Interactive comment on “Recent land subsidence caused by the rapid urban development in the Hanoi urban region (Vietnam) using ALOS InSAR data” by V. K. Dang et al.

Received and published: 5 February 2014

Fig. 1.[Full Screen / Esc](#)[Printer-friendly Version](#)[Interactive Discussion](#)[Discussion Paper](#)

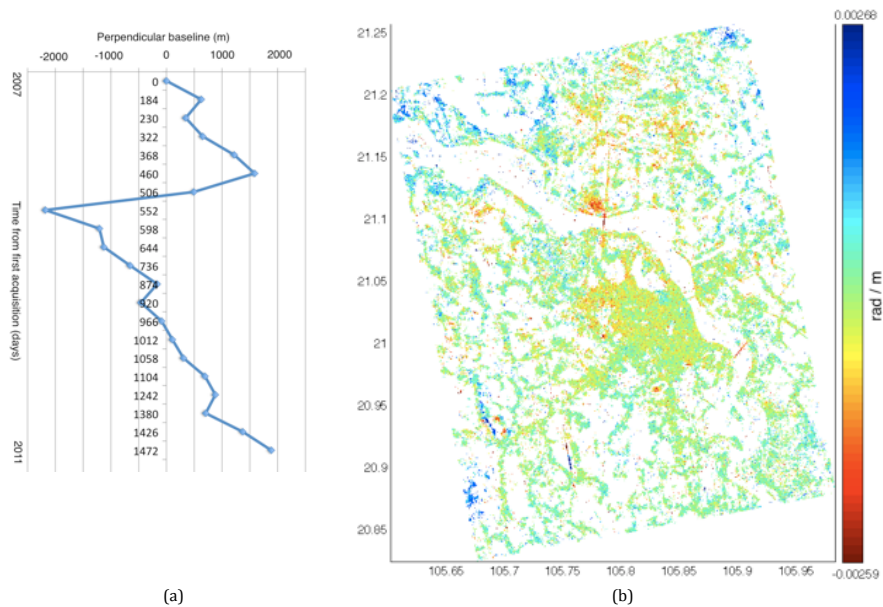
10/ Comment 10: Indeed a correlation of the perpendicular baseline with time is often observed with ALOS data, which if present will result in residual phase and map into spurious deformation signal. The figure below (left) shows the temporal correlation of the perpendicular baseline for the dataset used in this study, the temporal correlation (coefficient = 0.263) is low over the time period of four years. In our study, we apply the DEM correction method described in Hooper et al., 2008, the DEM error map is shown in the second figure (right). Given the temporal distribution of perpendicular baseline (i.e. low temporal correlation, high temporal variability), a DEM error affecting the mean velocity map would also be visible in the DEM error map. We do not observe such DEM errors at the locations of observed surface deformation, and therefore are confident that our displacement estimates are not affected by DEM errors. We added a reference of (Gourmelen et al., 2007) at line 8 P6157 and we modified the article at line 19, P6164 as follow: “ALOS time-series analysis can suffer from residual DEM errors due to the frequent temporal correlation of the perpendicular baseline (Samsonov, 2010; Chen et al., 2013), however in our dataset the temporal correlation of the perpendicular baseline is low and the inversion for DEM error is robust due to the temporal variability of the perpendicular baseline; we observe no DEM errors in the region of surface deformation.”
